Re: 2733 2nd Avenue - Cass Park - HDC2025-00575 **Project Revisions for Consideration**

September 26, 2025

CASS PARK

HISTORIC DISTRICT COMMISSION
OCTOBER 8, 2025

CASS PARK 2025 PROPOSED ENTRIES AND PATHS

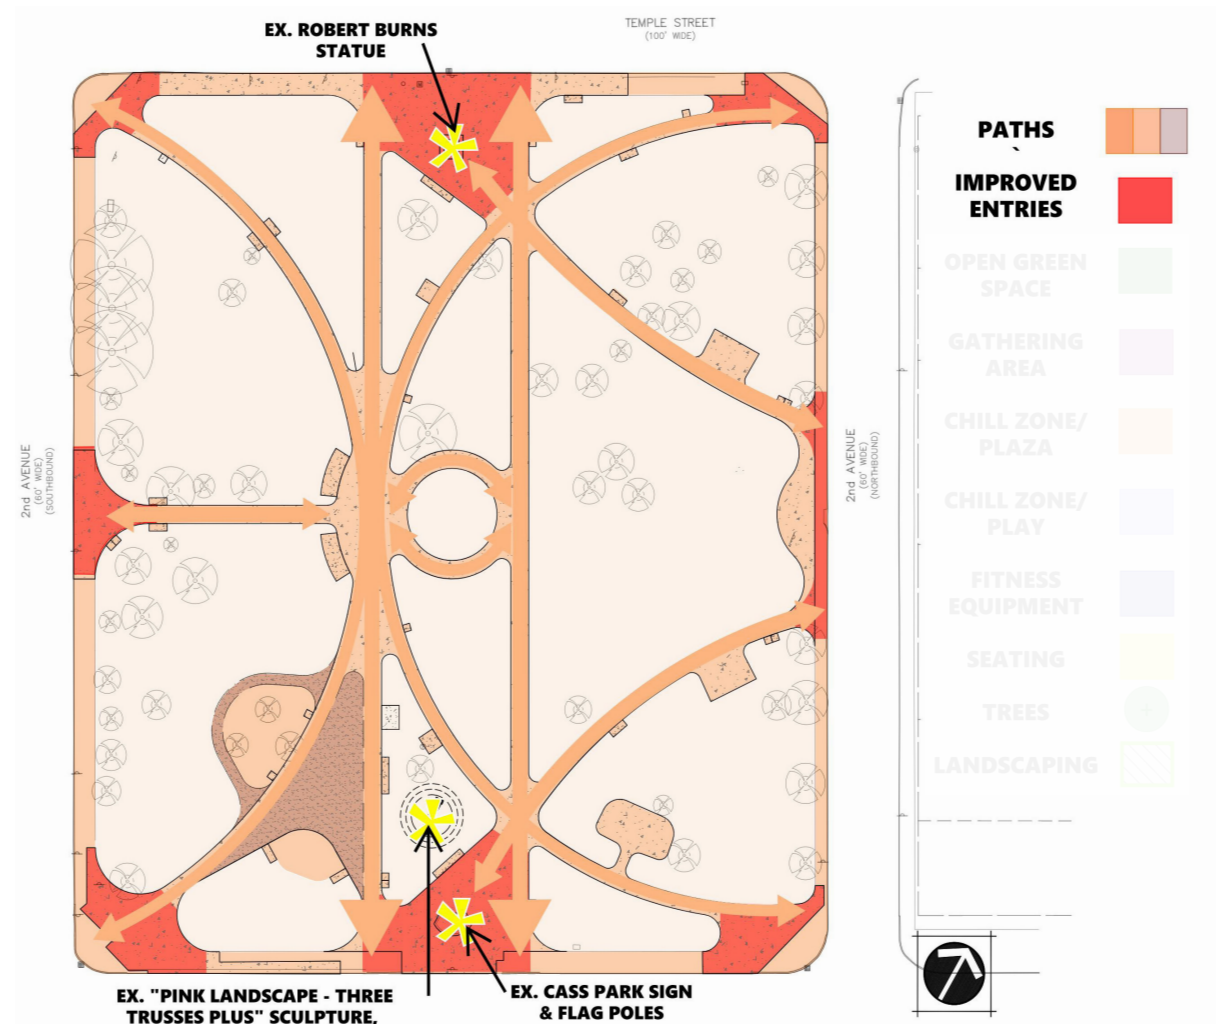
- Instead of one primary off-center pathway, the proposal now includes two symmetrical pathways that extend from 2nd Avenue through the park (pages A-10 and A-14).
- An avenue of trees that flanks the two symmetrical pathways through the park was enhanced, to emphasize the view down 2nd Avenue through the park, which was referenced in the historic significance considerations (page A-23).
- The large lawn space was reduced to accommodate the symmetrical paths (page A-15). To maximize the remaining lawn space for programming the mid-block plaza off east 2nd Ave was condensed, while retaining the function needed for the food service program (pages A-16 and A-20).
- A central focal point was added that is in the exact center of the park, referencing the historic fountain area, and connecting the park's pathways (page A-16).
